STAFF RECOMMENDATION

1507 Shelby Avenue
November 19, 2018

Application: New Construction-Revision to Previous Approval
District: Lockeland Springs-East End Neighborhood Conservation Zoning Overlay
Council District: 06
Map and Parcel Number: 08313049700
Applicant: Teri Preston
Project Lead: Melissa Baldock, melissa.baldock@nashville.gov

Description of Project: Application is a request to use white painted brick on infill already approved by the Metro Historic Zoning Commission.

Figures 4 & 5: Examples of historic brick colors.

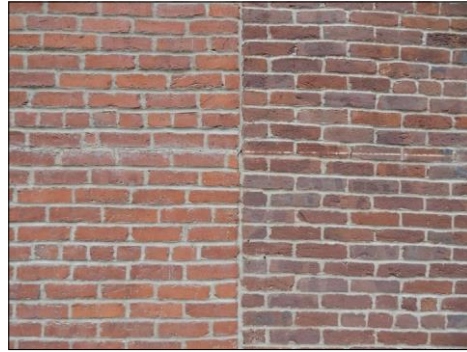
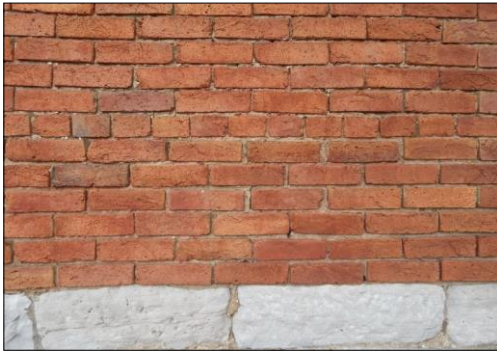
Historically, in the major period of development of the Lockeland Springs neighborhood, brick was un-painted. Brick houses of the Victorian, four square, Craftsman bungalow, and Tudor Revival styles were typically unpainted when they were built. Their bricks were typically earth-tones like reds, reddish-browns, dark oranges, tan, etc (Figure 4 & 5). If painted currently, it is likely that these houses were painted decades after they were constructed—either to mask brick repairs or deteriorating brick or to follow a trend where painted brick is meant to “freshen up” an older home. Historic brick and masonry have a protective porous surface that allows moisture to wick out; painting or sealing the brick or masonry can trap the moisture, leading to damage to the material after several freeze-thaw cycles. MHZC therefore strongly discourages the painting of historic brick.

For new construction, staff has encouraged brick to remain unpainted, although MHZC does not review the painting of brick. Painted brick is currently a trend in home building and home flipping, but trends like these can come and go (Figure 6 & 7). MHZC reviews the underlying brick for new construction to ensure that if an owner wishes to remove the paint in the future to provide for a more historically-compatible material and look, the underlying brick meets MHZC's standards and is similar to historic bricks found in the district.

The applicant is proposing a brick product that is already painted. MHZC staff finds that the proposed painted white brick is not visually compatible with the historic context as it is not known what the brick underneath the paint looks like. In addition, since the color is applied at the time of manufacturing, it may not be as easily removable as an applied paint. From the sample board and the image online, the brick underneath appears to be rough and tumbled with an uneven surface, which is typically not appropriate for brick in new construction in the historic and conservation overlays. Staff recommends disapproval of the proposed white painted brick, finding that its color and texture do not meet Section II.B.4 of the design guidelines.
